Re: Huntington Beach Energy Project (12-AFC-02)

Applicant's Responses to Staff's Data Requests, Set 2 (#73-98)

Huntington Beach Energy Project

Data Responses, Set 2

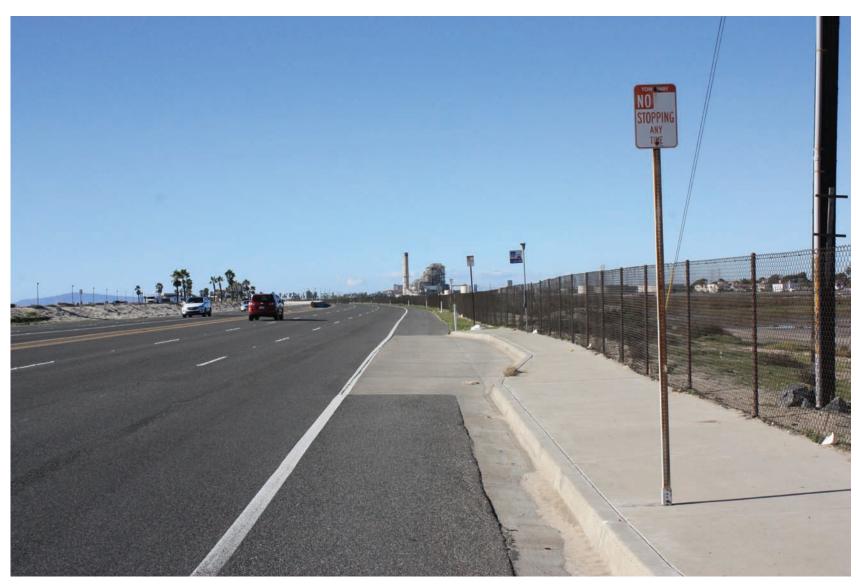
The project applicant has not yet proposed any mitigation measures to restore or enhance visual quality at the HBEP site, and assuming none are needed would be inconsistent with the intent of applicable state and local LORS. Staff needs to determine what mitigation measures may be feasible to reduce visual impacts of the HBEP site and achieve consistency with LORS.

- 98. Please prepare and submit a concept for a visual enhancement plan consistent with LORS for protection and enhancement of visual and aesthetic resources. The conceptual plan should include, at a minimum, proposals for screening facilities from public viewing areas (e.g., Huntington State Beach, the PCH, and Magnolia Marsh) during project construction and operation and improving views of project features and structures. Please discuss potential colors, methods, and architectural screening concepts that could achieve a degree of visual harmony with the proposed project's location in the Coastal Zone. Staff requests that the conceptual plan address these potential site and facility improvements for screening and enhancing public views of the site:

- A. Screening of the HBEP site during project construction phases, including suggested screening materials and heights of screening fences.

- Permanent decorative wall to replace the chain-link fence along the HBEP site perimeter, В. including suggested construction materials and wall height.3

- C. Potential locations to enhance existing landscape plantings and install new plantings.
- Potential alternatives to painting power plant structures, "flat gray," as specified in D. Table 5.13-1. The visual quality of bulky, geometric industrial-type structures is not necessarily improved by painting the conglomerated structures in the same continuous color of flat gray. The visibility of such structures would not necessarily be reduced.

- E. Architectural screening of all prominent industrial equipment that would be visible from public viewing areas, including suggestions for types of screening that could be available to enhance the visual appearance of the equipment (e.g., panels, unique metal screen or mesh façade, louvers, etc.).

Response: Applicant reiterates and incorporates by reference its objection to this Data Request, as set forth in the Applicant's January 9, 2013, correspondence to Felicia Miller and the Siting Committee.
